# Review of the Arkansas Nuclear One Generating Station Unit No. 1 Emergency Feedwater System Reliability Analysis

Prepared by R. Youngblood, I. A. Papazoglou

Brookhaven National Laboratory

Manuscript Completed: September 1983  
Date Published: February 1984

FIGURE 1  
EMERGENCY FLOOD  
WATER SYSTEM

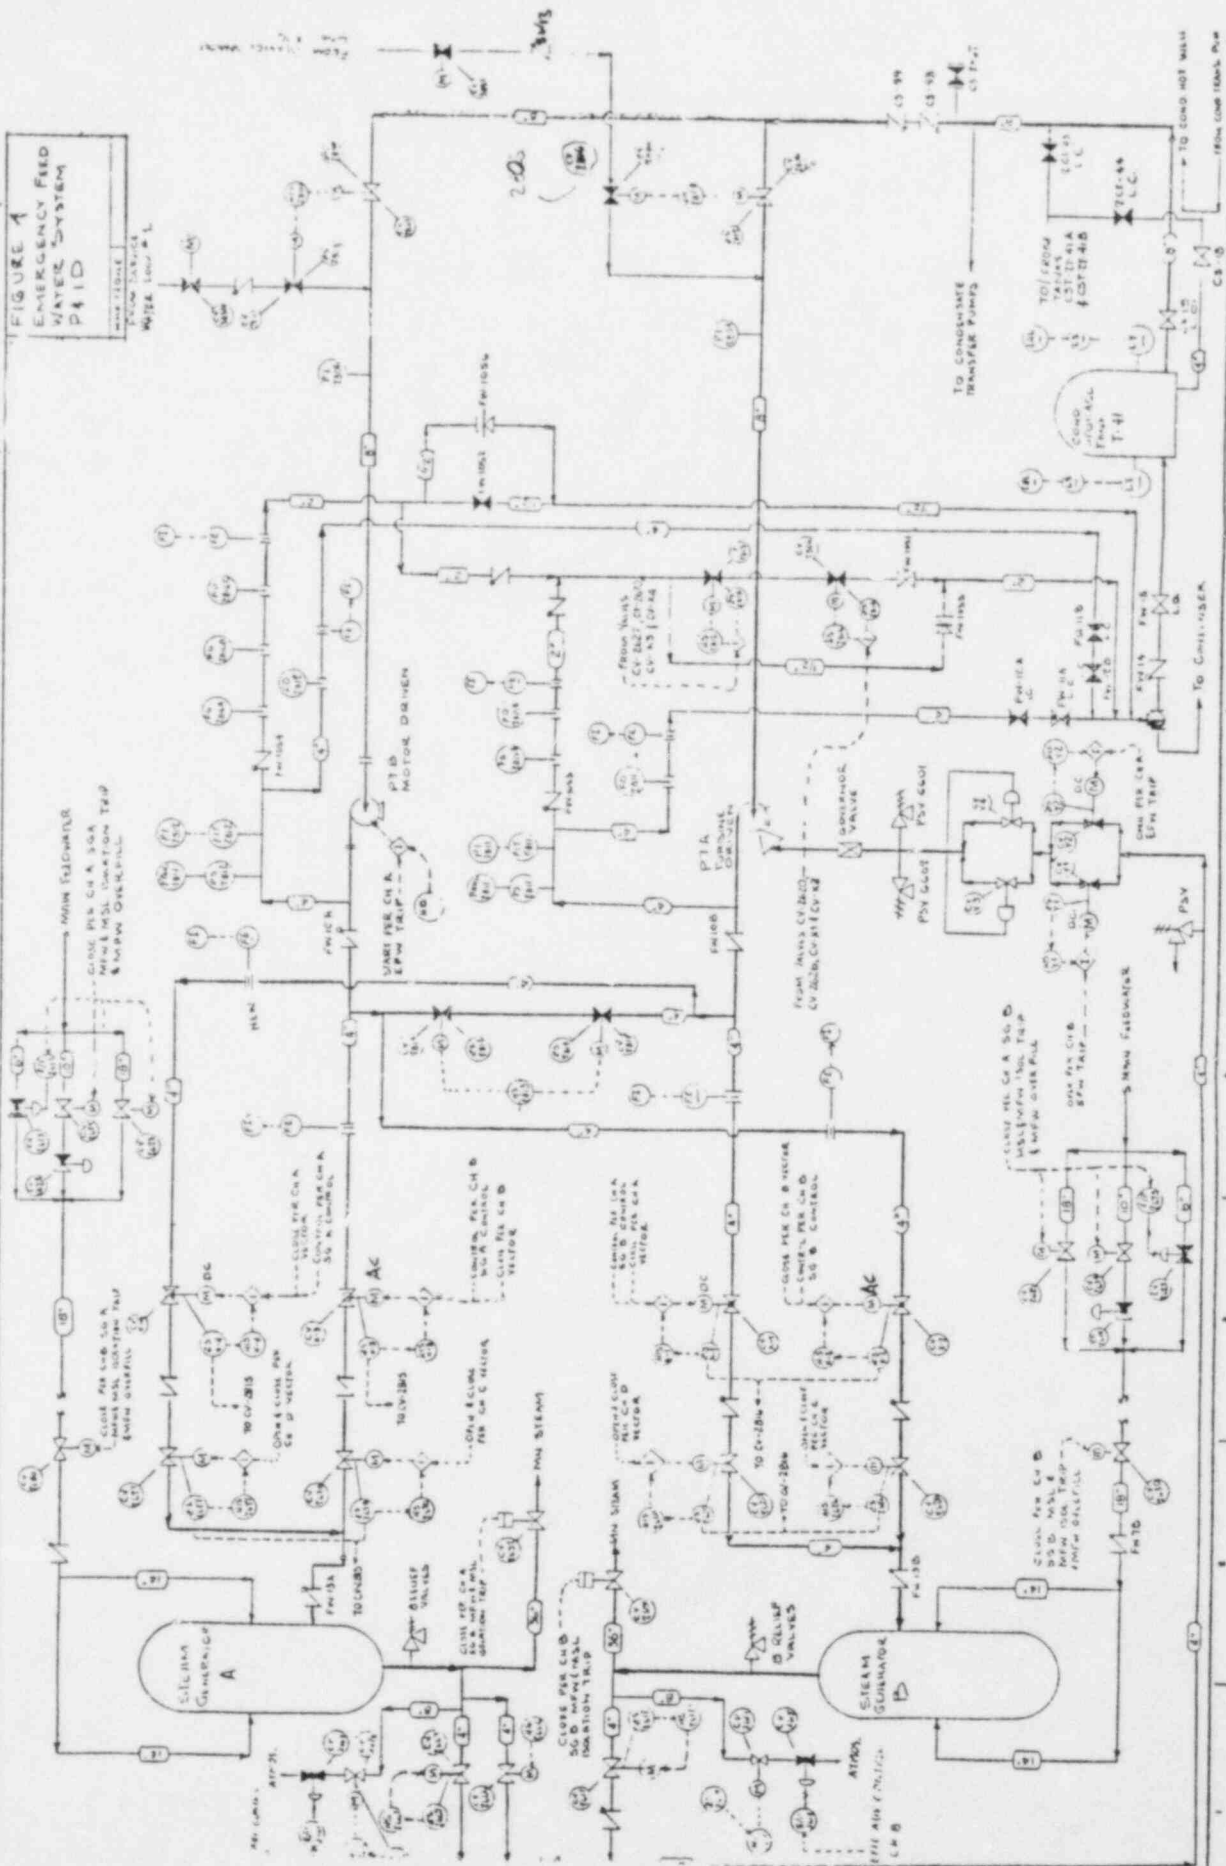
There are two channels of initiate logic (A and B). At ANO-1, both channels are connected to both pumps. (The system diagram shows only channel

A connected to the EMD pump, but the fault tree shows both channels connected to both pumps. It is assumed here that the fault tree is correct.) Thus, failure of one channel of logic alone has no effect on the system; the other channel actuates both pumps. This contributes to system reliability in this analysis (the possibility of interaction degrading both channels is beyond the scope of this report). Failure of both channels fails automatic initiation of both pumps; this event is listed separately from contributors to Q1 and Q2 (Table 6.3).

A total loss of pump recirculation flow could be caused by blockage of either FW14, FW15, or the three-way valve immediately upstream of these. If total loss of recirculation can fail both pumps, then these are single failure

points of the system. It is not clear that these will be conditions under which minimum flow requirements will not be satisfied by system demand; but from the given description of EFIC control logic, such an event is at least a strong possibility. Actual data on the time dependence of auxiliary feedwater demand are sparse; but the event at TMI-2, which is documented in some detail, is suggestive. EFW control valves did not open for some 35 seconds after trip, because this was the elapsed interval before the SG level setpoint was reached. The block valves, of course, remained closed for some extra time, which also would certainly contribute to a need for minimum flow protection. A delay on the order of minutes before EFW flow is demanded would appear to be credible, and minimum flow protection would appear to be necessary for such conditions.  $10^{-4}$  has therefore been assessed for each of the three single-point recirculation-blockage events. This value is probably conservative for the manual valve and the three-way valve, but not for the check valve.

There are two trains in the EFWS (see Figure 1). Each train consists of one pump and a pair of discharge paths, one to each steam generator. Mission success is defined as adequate flow from one pump to one steam generator within the appropriate time (see Section 3). Therefore, failure of the EFWS is:

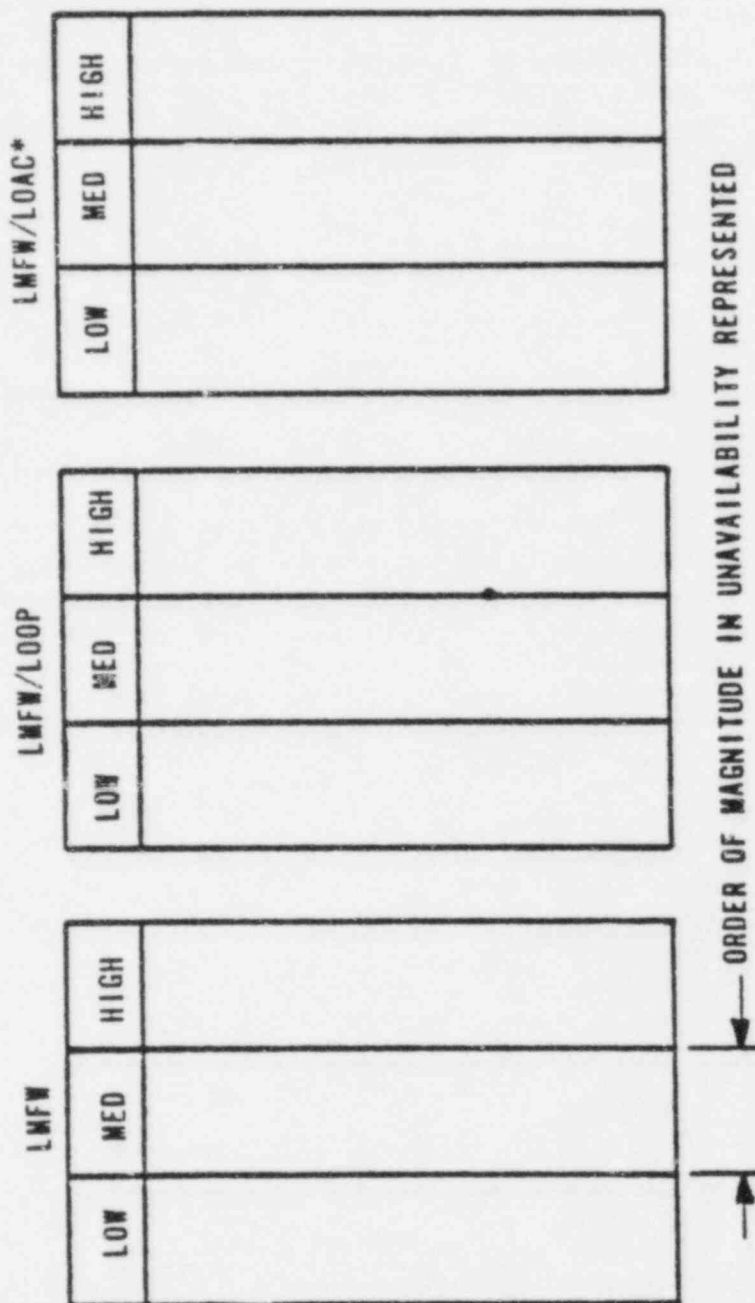
It is possible for a channel, in this case Channel C, to fail. It is conceivable that such a failure could isolate both discharge paths from the turbine driven EFW pump. However, the single failure criterion as applied to the EFW system requires that at least one pump be able to supply EFW to at least one steam generator. Isolation of the turbine driven pump would require the following additional failures before the EFW system would be inoperable:

1. Loss of offsite power (LOOP)
2. Loss of both Diesel Generators (LOAC)

Thus the single failure of channel C would not render EFW inoperable.
